**CULTURAL RESOURCES OFFICE
PRESERVATION BOARD
REGULAR MEETING
MONDAY – JULY 25, 2016 — 4:00 P.M.
1520 MARKET ST. #2000
ST. LOUIS, MO. 63103
www.stlouis-mo.gov/cultural-resources**

DATE: July 25, 2016
ADDRESSES: 1302-24 Russell Boulevard
ITEM: Construction of a multi-story apartment building; demolition of two vacant industrial buildings.
JURISDICTION: Soulard Local Historic District; Soulard National Register Historic District Ward 7
Staff: Jan Cameron, Cultural Resources Office

DATE: July 25, 2016
ADDRESS: 4161 Castleman Avenue
ITEM: Preliminary Review: Construct a new front porch and front door replacement
JURISDICTION: Shaw Neighborhood Local Historic District — Ward 8
STAFF: Bob Bettis, Preservation Planner, Cultural Resources Office

DATE: July 25, 2016
ADDRESS: 5780 McPherson Avenue
ITEM: Preliminary Review: Construction one single-family house
JURISDICTION: Skinker-DeBaliviere Certified Local Historic District — Ward 26
STAFF: Bob Bettis, Cultural Resources Office

PROPOSED NEW PORCH AND ALTERED ENTRY

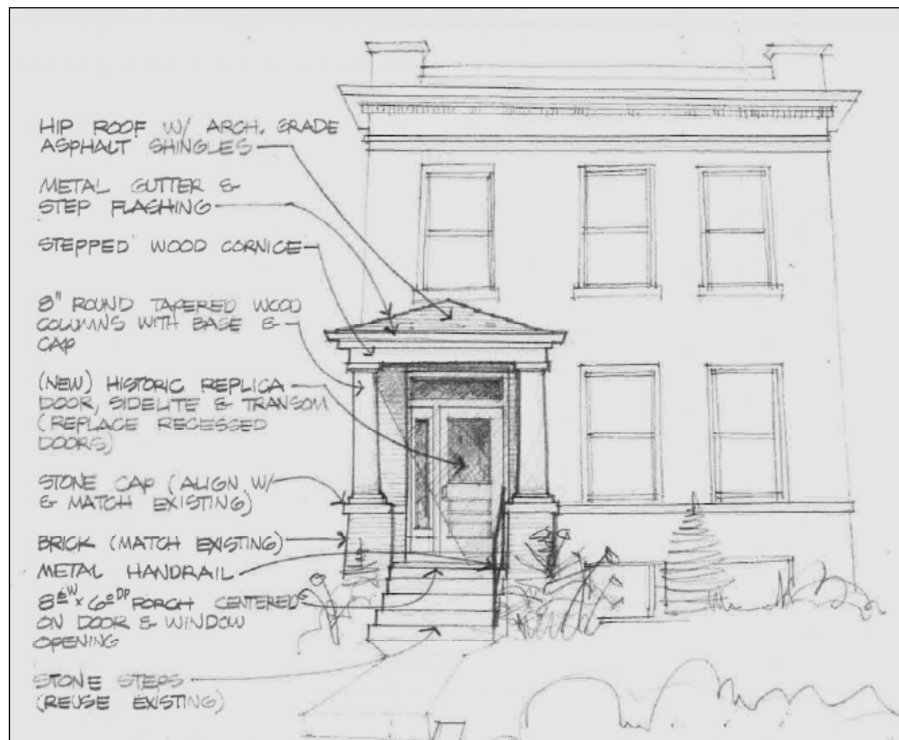
Does not comply. The house, constructed in 1906, was constructed with a recessed entry in place of a porch. Although the proposed porch is of an appropriate design, the introduction the new feature is counter to the Standards which state that original details should be retained in their original configuration.

The owners also are proposing to enclose the recessed entry and to install a single door with sidelight in place of paired doors. This is also not compliant with the Standards as gives the entry an appearance it never had historically.

- The Cultural Resources Office and the Preservation Board have never supported the conversion of an existing paired entry to a single entry.

Based on these preliminary findings, the Cultural Resources Office recommends that the Preservation deny the Preliminary Application to construct a new front porch and enclose the recessed entry, as the alterations do not comply with the Shaw Neighborhood Local Historic District standards.

FRONT ELEVATION

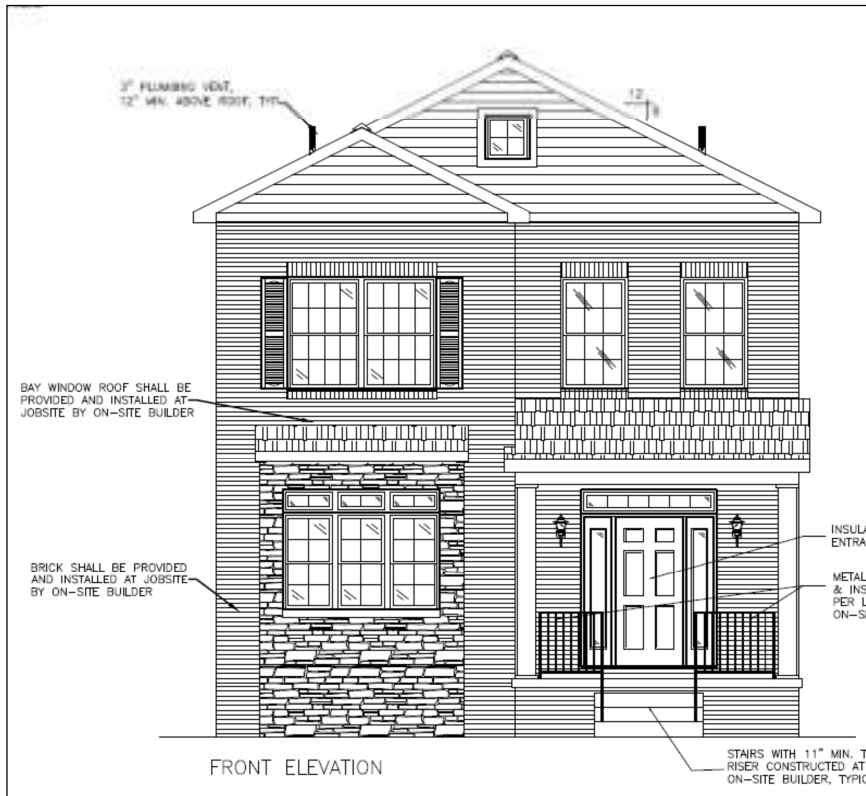
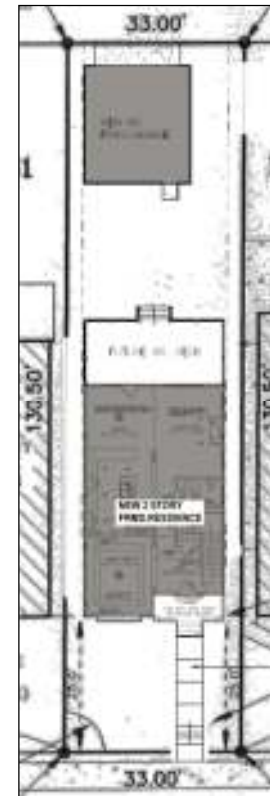
Complies. There are a variety of building heights on this block, but the proposed building appears to meet this requirement.

Complies. The proposed setback is in line with the adjacent buildings.

Complies. The proposed building will have a brick front façade that will return on the sides that match the distance between the adjacent houses.

Complies. Proposed building floor heights, window proportions, scale and materials are compatible with the adjacent buildings.

Complies. There are a number of different roof types on the block. The selected gabled roof is compatible with the surrounding structures.

Based on the Preliminary findings, the Cultural Resources Office recommends that the Preservation Board grant preliminary approval for the proposed new construction with the condition that the design be developed as proposed and that final design details and materials will be reviewed and approved by the Cultural Resources Office to ensure compliance with the district standards.

PROPOSED EAST (KINGSHIGHWAY) ELEVATION

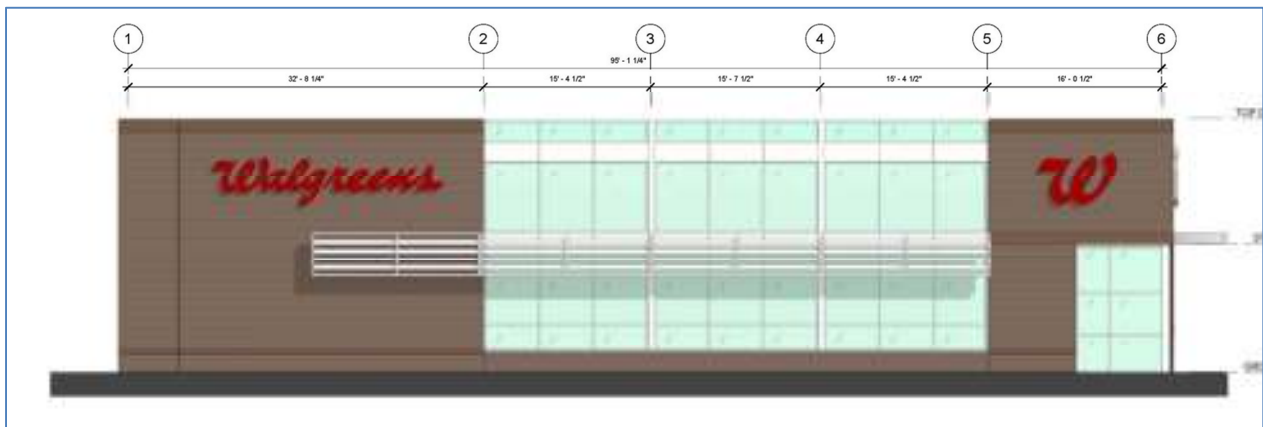
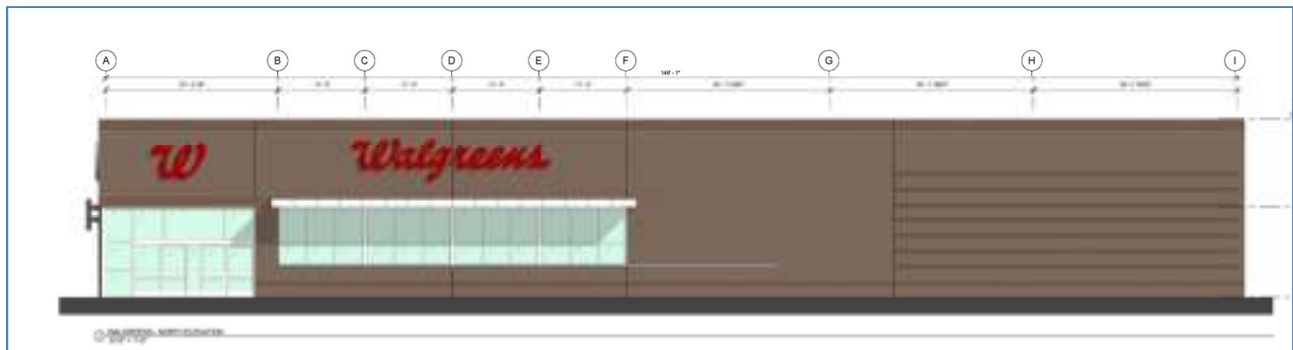
- The cost estimate does not include the added value of historic tax credits for which most of these buildings would qualify.
- By keeping two of the Merit structures and placing the Walgreen's building at the sidewalk, the proposed new construction maintains the urban form of the streetscape, although the configuration of two curb-cuts and parking will leave gaps that lessen the urban character of the streetscape.
